Evaluation of the AoR Delineation Modeling Approach in Carbon TerraVault's Monterey Formation A1-A2 Class VI Permit Application

This area of review (AoR) delineation modeling evaluation report for the proposed Carbon TerraVault 1 LLC (CTV) Class VI geologic sequestration project summarizes EPA's review of the modeling performed by CTV as described in the Area of Review and Corrective Action Plan (AoR CA), which is Attachment B to CTV's August 2021 permit application and associated files submitted to the AoR and Corrective Action Module of the GSDT. This review also addresses modeling-relevant site characterization information in the permit application narrative and in the PISC and Site Closure Plan (Attachment E). Because the AoR modeling accounts for both of CTV's proposed injection wells (357-7R and 355-7R), this evaluation applies to both wells. Clarifying questions for CTV and requests for supplemental information are provided in blue within the text below.

Figure 4: Schematic section of the storage site with inputs to critical pressure calculation. Values for the USDW are based on the 326-7R well. The injection depth is based on the 357-7R injector. Using data from wells 357-7R injector and 326-7R the critical pressure is 3,400 PSI.

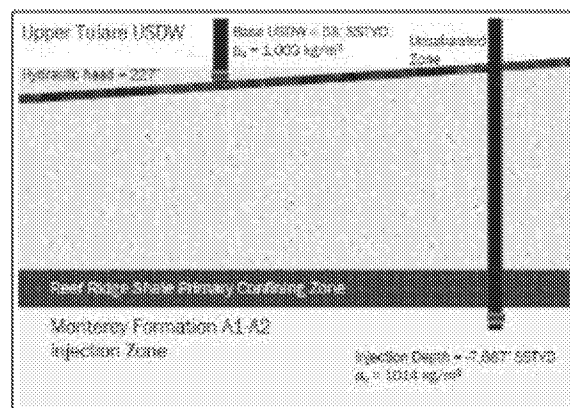
- *Please define the variables shown in the critical pressure calculation and their corresponding values shown in Figure 4 of the Critical—Pressure—Calculation PDF.*
- *The injection depth shown in Figure 4 of the Critical—Pressure—Calculation PDF (7,687 ft SSTVD) is different than the perforated depths shown in Table 5 of the AoR CA (7,728 ft MSL). Please confirm that this difference is due to ground level reference elevation. If not, please change the depth in Figure 4 and/or Table 5 to reflect the correct injection depth.*
- *If any of the 152 wells in the AoR penetrate the entire Reef Ridge Shale, please explain how they are accounted for in the geomodel.*
